LINE	QUANTITY	UOP	CAT. NO.	ITEM NUMBER	UNIT PRICE	AMOUNT
ADDENDUM NO. 03						
THIS ADDENDUM HAS BEEN ISSUED TO AMEND THE ORIGINAL SOLICITATION PER THE ATTACHED DOCUMENTATION.						
0001	1	LS		968-20		
NEW FAIRMONT OFFICE BUILDING CONSTRUCTION

Addendum No. 3  
June 19, 2013

To: ALL BIDDERS  
Ref: **New State Office Building-Fairmont**  
Subj.: **ADDENDUM BULLETIN NO. 3**

**1 SECOND FLOOR ROLLER WINDOW SHADE PLAN**  
 SCALE: 1/16" = 1'-0"  
 SHEET: SK-06

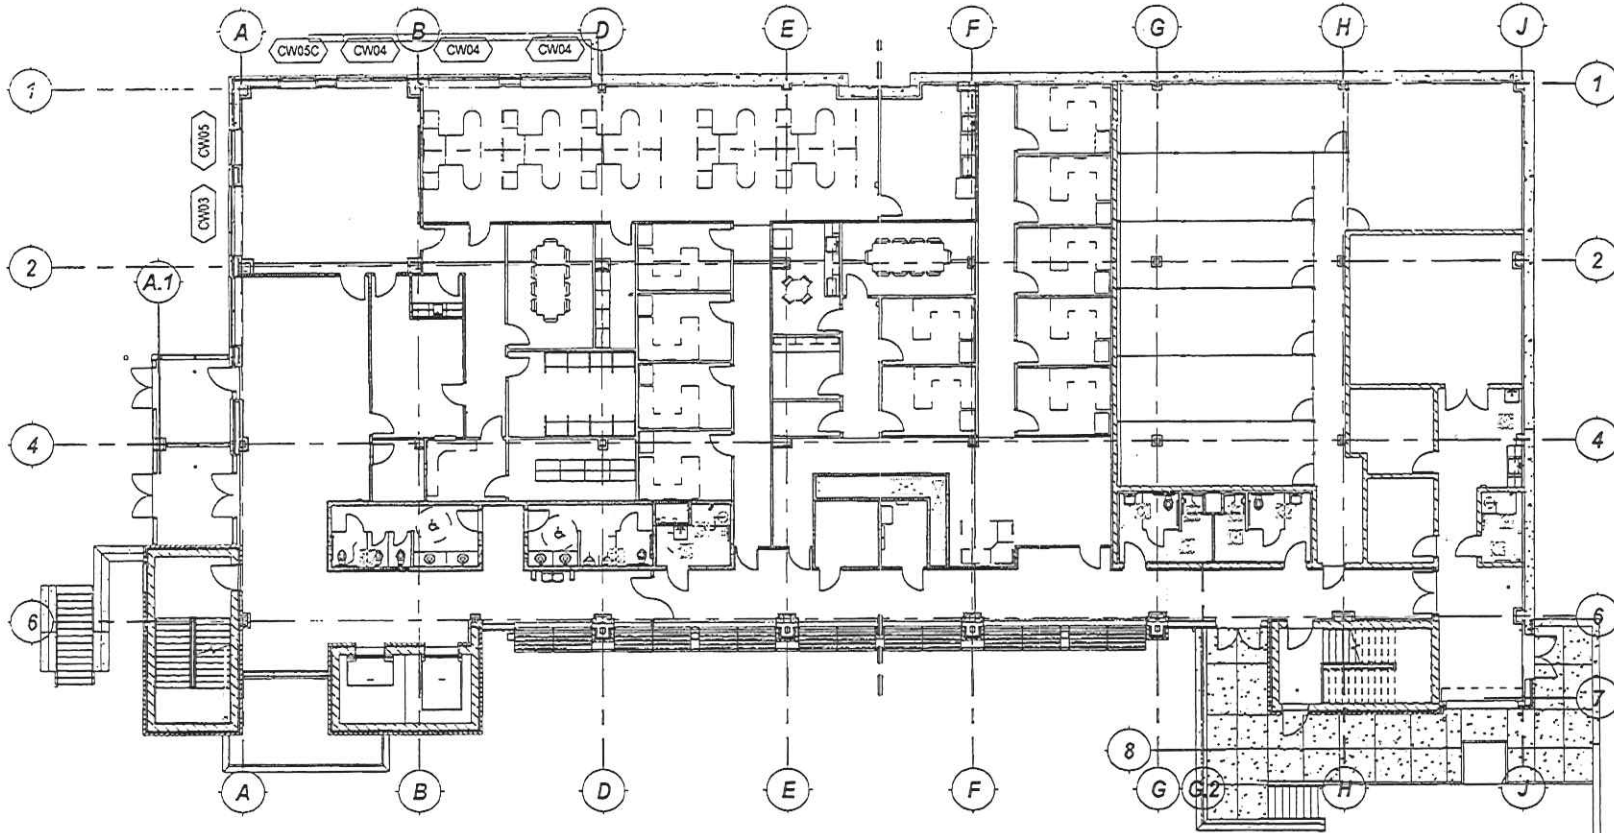
"A. Install Roller Window Shades at every opening marked with a curtainwall window tag annotation ("CW" followed by a number in a hexagonal box) that appears on the following sketches that are Attachments to Addendum No 3:

Some curtainwall openings will require multiple shades to completely cover opening. Shade separations to occur at vertical window mullions. Some curtainwall openings are divided by a partition and will require more than one roller window shade.
